Urgent Field Safety Notice

SBN-SIS-2019-002

Loose screws on the Tray Input Flap of the cobas p 501 /p 701 post-analytical units

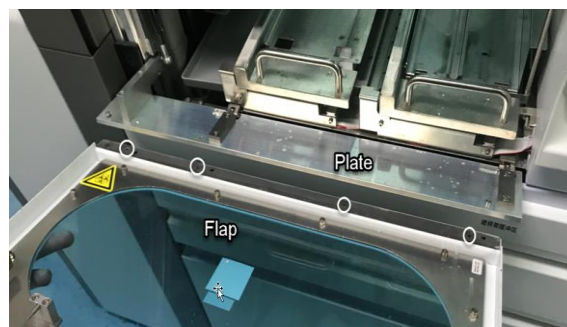
The Tray Input Flap screws can become loose on the cobas p 501 or p 701 post-analytical units resulting in the potential detachment from the instrument.

Visual inspection of the Tray Input Flap, plate and screws were performed. As demonstrated in the pictures below, the flap was no longer attached to the instrument and the 4 M3 threads on the Tray Input Flap were worn out resulting in the screws not working as intended.

The Tray Input Flaps on instruments with the above listed serial numbers must be replaced by Roche Diagnostics with the current design of the tray input flaps with an estimated completion date of 30-September-2019.
